UNITED STATES PATENT AND TRADEMARK OFFICE

10/572,775

Office Action Summary	Application No. 10/572,775	Applicant(s) VULETIC, BOGDAN	
	Examiner JASON L. LAZORCIK	Art Unit 1791

DETAILED ACTION

【図2】

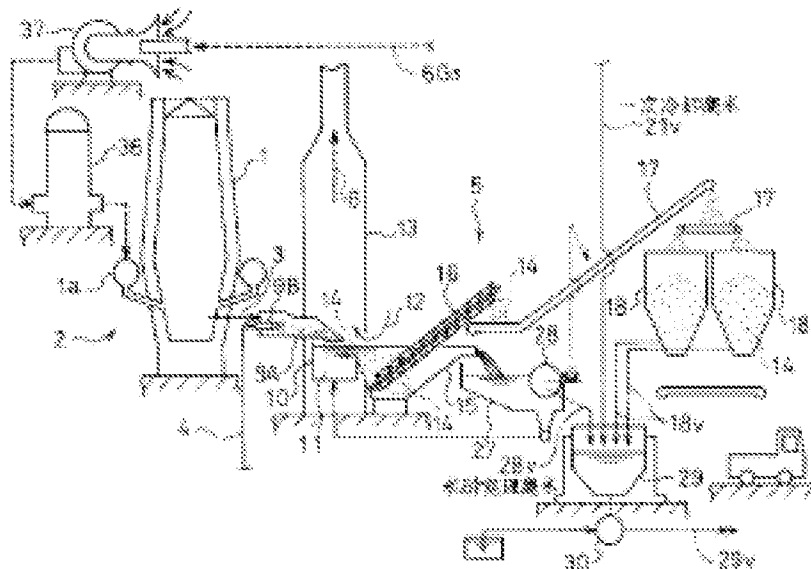
11. Regarding independent **Claim 1** and with particular respect Kiyoshi figures 1, 2, and 3 (see particularly excerpt figures 1 and 2 below), Kiyoshi teaches a process for granulating slag from a blast furnace (2).

The reference specifically teaches feeding a granule/water mixture formed during granulation (9A, 9B) to a granulation tank (1) then to a dewatering installation (5) to dewater the slag granules.

H₂S-containing vapors and gases (6G) formed during the granulation are at least partially condensed by water injected at a water injection point (21b) in the condensation space (13) which is flow connected to the granulation tank (10). Residual H₂S gases are discharged from the condensation space (13) below the water injection point (22a). The discharged gases (6G₃) are directed in “countercurrent” or recycled back to the slag blast furnace (2) wherein the gases are burned (¶[0070]) during formation of hot slag or “through a hot slag channel”.

【図1】

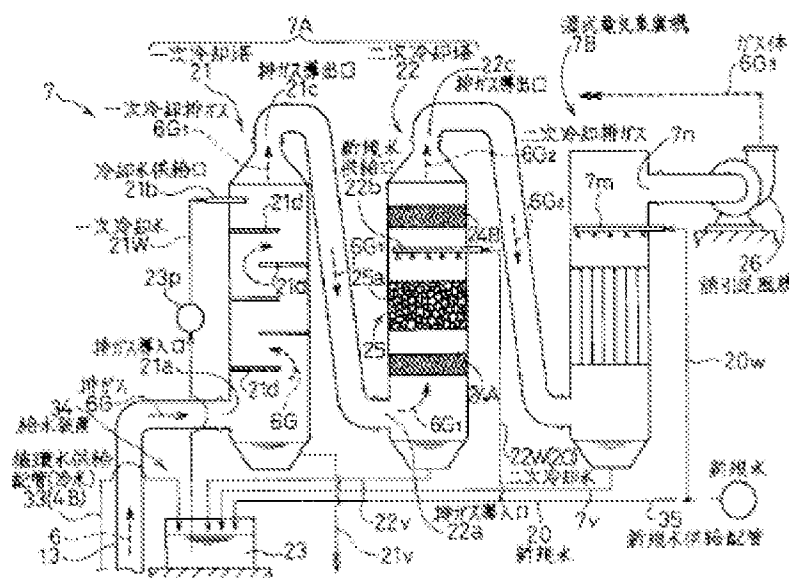
Regarding **Claim 2**, the blast furnace (2) which is capable of supporting gaseous combustion process therein is construed to read upon the claimed combustion chamber.

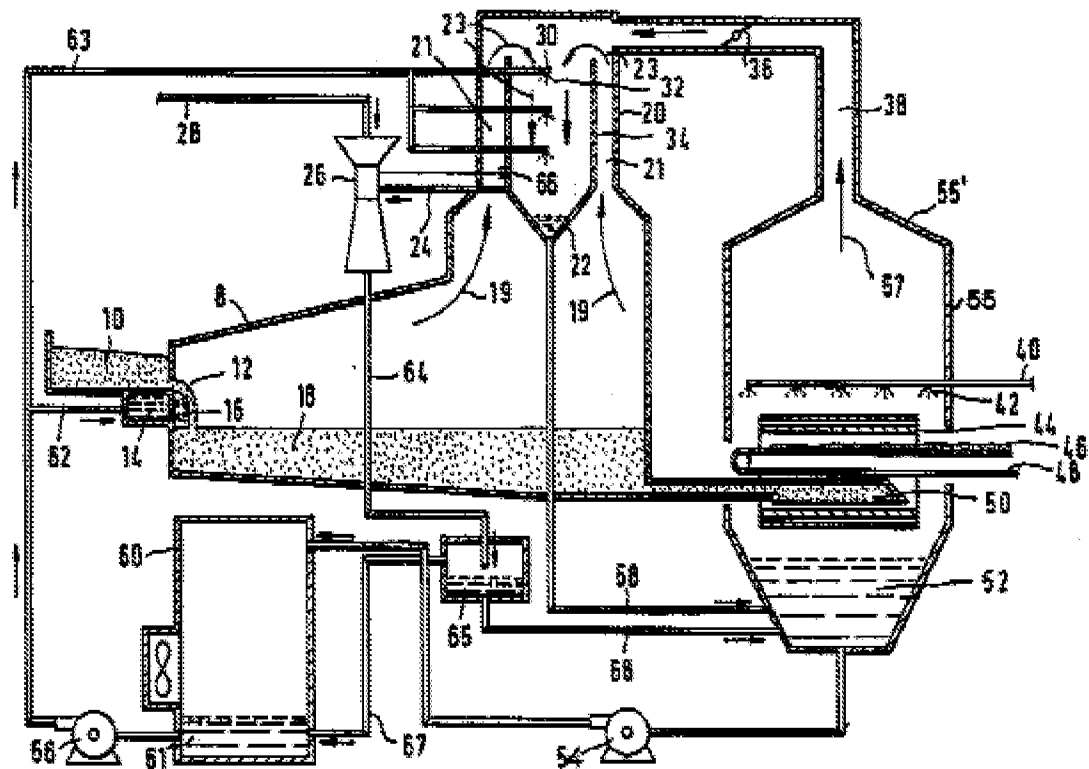
The United States patent to Faber (US 5,540,895) teaches a method for granulating slag with recovery of sulfur contaminated vapors. Specifically Faber teaches

feeding a granulated slag mixture to a granulation tank followed downstream by a dewatering apparatus. In the disclosed process, contaminated steam (19) generated during the granulation is at least partially condensed by injection of water from nozzles (30) in a condensation space. The reference further teaches that uncondensed gases are discharged below the water injection point (60) and recycled through the liquid scrubber system.

With respect to Claim 5, Faber teaches that the condensation tower (20) is closed at its lower end and separated from the dehydration or "dewatering installation" by a water barrier (Col. 4, lines 64-67). Faber teaches that such an arrangement "prevents the gases that are formed during the granulation process from being entrained towards the dehydration plant.

Similarly regarding Claim 7, Faber provides for a return conduit (38) from the dewatering installation back to the condensation tower (20) at a point above the water injection point for purification in the same manner as the contaminated steam originating from the granulation tank (Col. 6, lines 41-56). Such a vapor recovery insures more complete recovery of harmful H₂S and SO₂ gases from the granulation and dewatering facilities.
